Service letter NO. 2
Model effected See Des M-4 & M-4
Serial number effected 3-55

It will be required to add a balance weight to the elevator of your aircraft. I am forwarding with this letter the required weight, attaching hardware and installation drawing.

BOTTOM VIEW TYPICAL BOTH SIDES

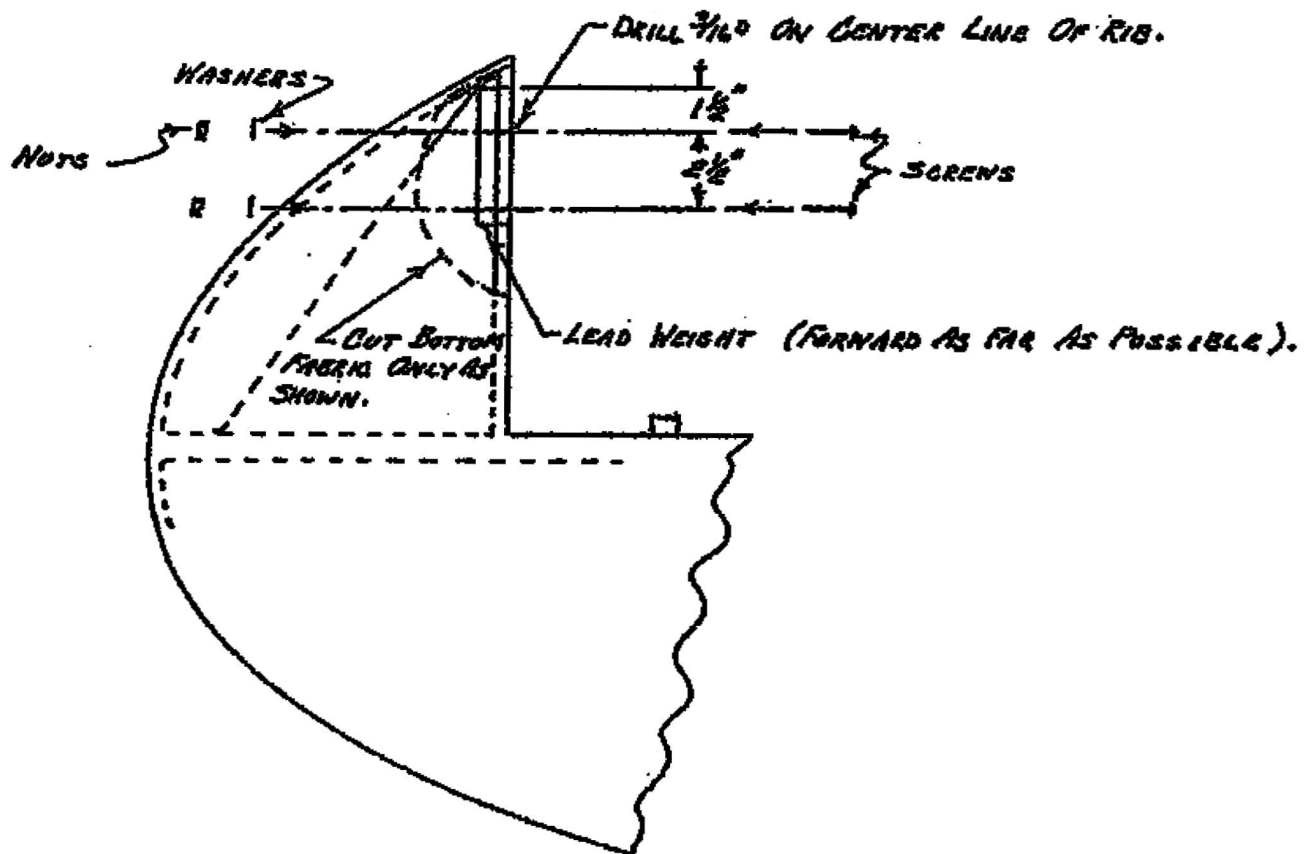
1. Lead Weights (2 req'd) (per dwg CD-A560).
2. Screws AN526-10-R24 (4 req'd)
3. Nuts AN365-1032 (4 req'd)
4. Washers AN960-10 (4 req'd)
5. Fabric covering and dope. (use butyrate dope).

1. Remove fabric from bottom of elevator as shown on drawing.
2. Install lead weight as far forward as possible and clamp it to the rib for drilling.
3. Drill the two $3/16$ holes at the locations noted on the drawing.
4. Install the screws, washers and nuts as noted.
5. Recover out cut area as per CAMLS.
